# UNITED STATES PATENT AND TRADEMARK OFFICE

10/524,863

<b>Office Action Summary</b>	<b>Application No.</b> 10/524,863	<b>Applicant(s)</b> SATO, TADAYOSHI	
	<b>Examiner</b> BENJAMIN KURTZ	<b>Art Unit</b> 1797

## DETAILED ACTION

**1. Claims 5, 7 and 8 are rejected under 35 U.S.C. 102(b) as being anticipated by Kelly US 1 164 527.**

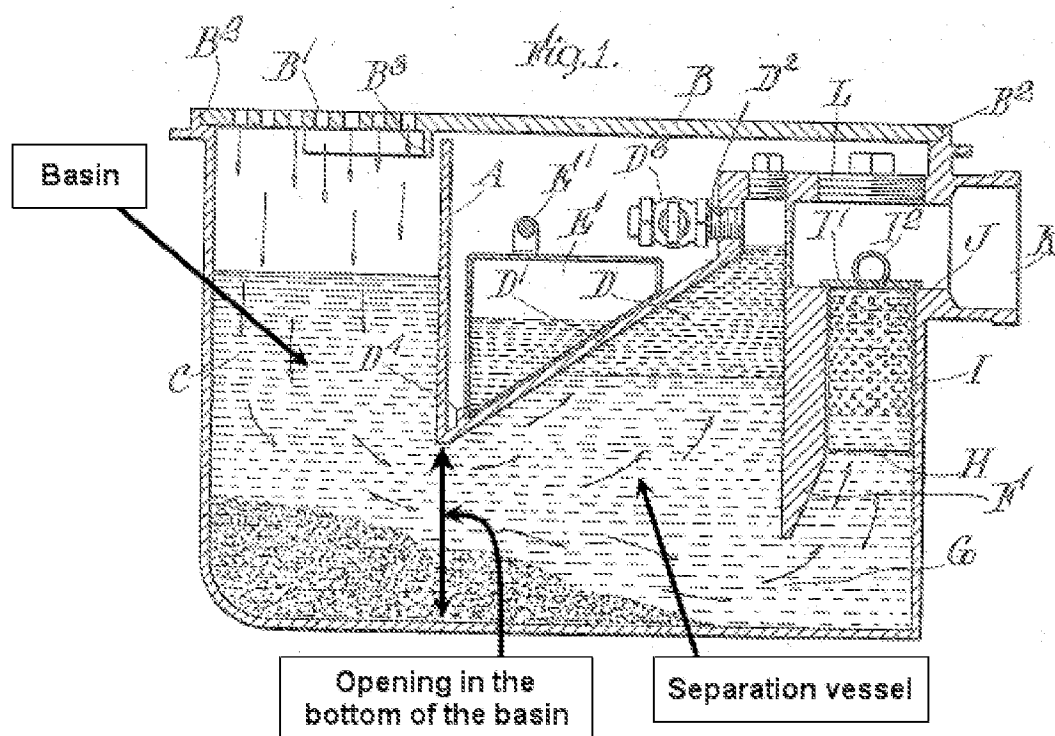
Regarding claim 5, Kelly teaches a sink comprising: a basin (C) having a bottom with an opening, a separation vessel communicating with the opening, a water storage vessel (H) forming a u-shaped passage as a whole together with the separation vessel, a draining means (K), and an open/close means (D3) provided at the side of the separation vessel (fig. 1). How the apparatus functions is a process limitation that does not add structural limitations to the claim.

Regarding claim 7, Kelly further teaches the separation vessel and the water storage vessel are adjacent each other with a common partition member (F) forming the u-shaped passage, and the draining means (K) has a structure with an inlet formed at a

position of the predetermined fluid level on a circumferential side wall of the water storage vessel and a pipe shaped member formed out so as to connect the inlet and outside of the water storage vessel (fig. 1).

Regarding claim 8, Kelly further teaches the separation vessel and the water storage vessel are adjacent each other with a common partition member (F) forming the u-shaped passage, and the draining means (K) has a structure with an inlet formed at a position of the predetermined fluid level within the water storage vessel and a pipe shaped member formed out so as to connect the inlet and outside of the water storage vessel (fig. 1).
